**Modification Report | Section 4.55(1A) Modification Application to SSD-8925
New Sydney Fish Market, Bridge Road, Glebe**

This application has been prepared by Ethos Urban on behalf of Multiplex Constructions Pty Ltd, pursuant to section 4.55(1A) of the *Environmental Planning and Assessment Act 1979* (EP&A Act) to modify State Significant Development Consent SSD-8925 relating to the new Sydney Fish Market (SFM) Stage 2 at 1A, 1B and 1C Bridge Road, Glebe (the site).

The modification relates to a proposed change to the project construction methodology involving the building up of a sediment capping layer and work platform within the coffer dam beneath the approved basement for the new Sydney Fish Market.

Figure 1 Diagrammatic illustration of proposed sand pumping method

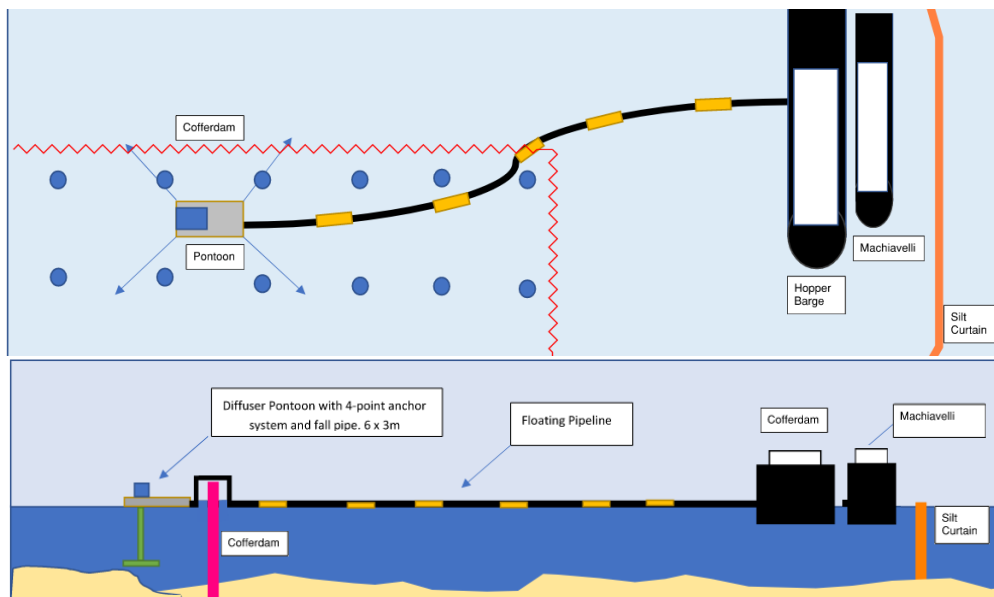
Details of the methodology for the sediment capping is outlined in **Attachment C**. The sediment capping works will be carried out by machinery previously used on the new Sydney Fish Markets site. Sand will be primarily brought to the site via barge(s) staged from Glebe Island, and pumped from outside the cofferdam (but within the silt curtain) into the basement footprint within the cofferdam. A non-propelled 'split hopper barge' will be moored alongside a backhoe profiling barge (which provides mooring) and has a capacity to store up to 1,200m³ of material. The sand material to be installed will be loaded onto the 'hopper barge' at a storage facility in Glebe Island which is currently being used on the project. The hopper barge will have sand pumped directly from the hopper to the workface via pump. A pontoon located inside the cofferdam will help position and release the end of the pumping line to evenly distribute the sand across the cofferdam footprint. The works will progress working behind the cofferdam and marine piling works. **Figure 1** illustrates the sand dispersal methodology.

Figure 2 Extent of proposed capping

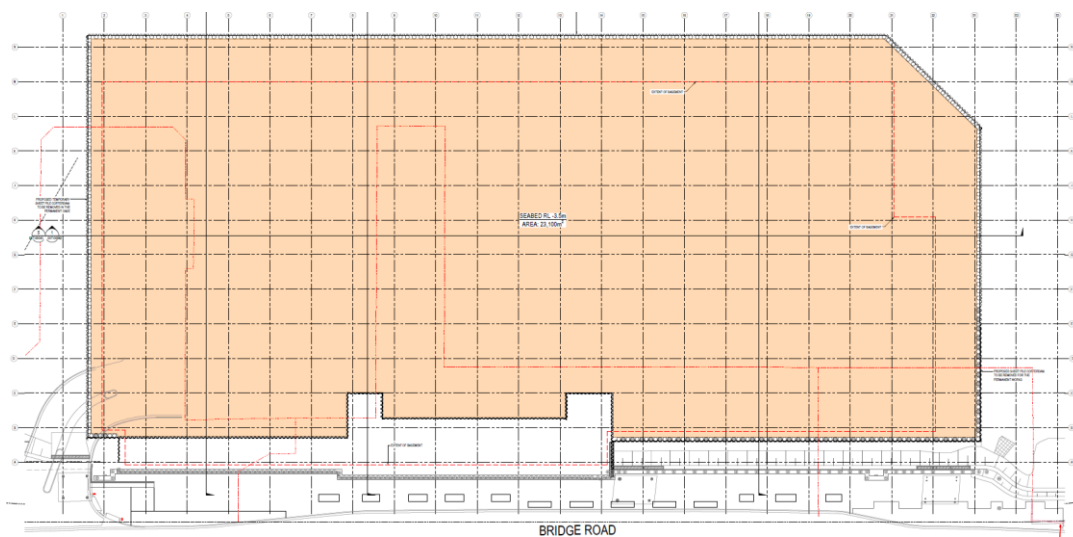
As previously assessed and approved in MOD 4, the approved development includes the redistribution of approximately 12,000m³ of sediment generally beneath the footprint of the approved basement. This Modification Application seeks consent for a cap of clean fill – virgin excavated natural material (VENM) – comprising sand (approx. 80% of volume) and crushed sandstone (approx. 20% of volume) to be imported onto the site and placed above the layer of redistributed sediment within the basement extent and confines of the temporary cofferdam to a finished level of RL -3.5m AHD (approximately 1600mm depth). **Figures 2 and 3**, and as further detailed in **Attachment A**, sets out the proposed extent of the fill layer.

Figure 3 Section of capping with coffer dam, and post-completion of basement and dam removal

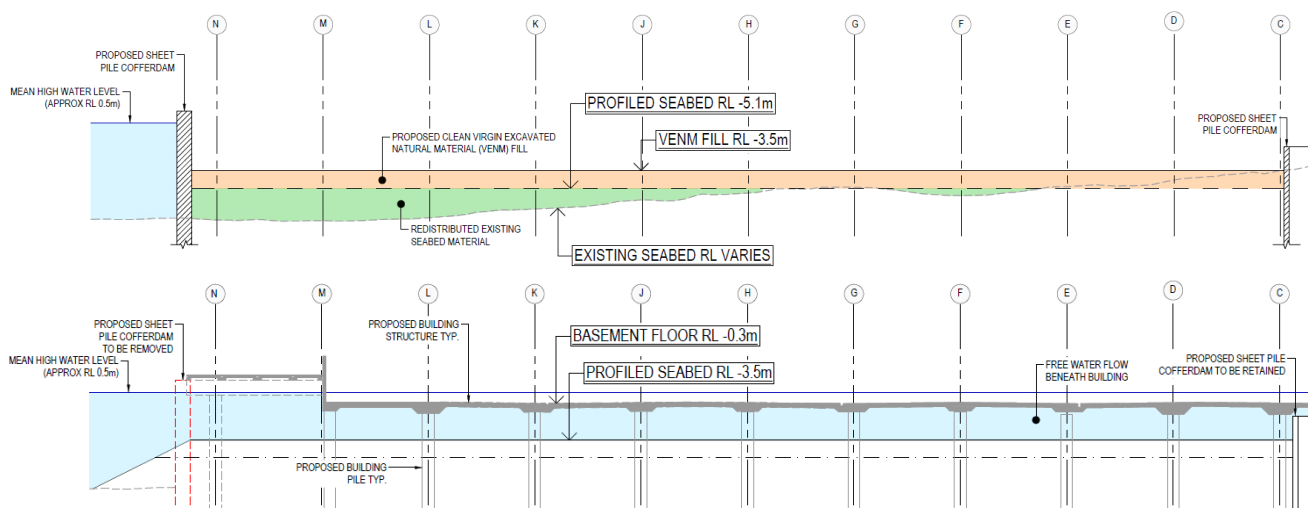
The completion of the marine based installation of the sediment capping works coincides with the dewatering of the cofferdam. At this stage, the level of the sediments will be -3.9 AHD, which is 200mm above the dewater level. Following dewatering, the remaining sediment capping layer of crushed sandstone will be installed via land based machinery and work progressively out from land to the extents of the cofferdam footprint, in sequence with the construction of the buildings structure. Traditional excavators and earth moving equipment will be utilised for the planned works, building the sediment level up to -3.5 AHD, which is approximately 2.93m below mean low water tide (-0.57 AHD). Crushed sandstone and the final deliveries of sand not able to be pumped will be trucked to the site, in accordance with the updated Construction Traffic and Pedestrian Management Plan (**Attachment D**), and distributed within the cofferdam above the sand layer by earthmoving equipment.

The proposed changes will result in an increase in the seabed height beneath the site from RL -5.1m to RL -3.5m AHD. Both the redistributed sediment and the capping layer will continue to be wholly below the lowest minimum tide level, and will continue to provide for the inflow of water between the upper layer of capping and the lowest approved basement structures.
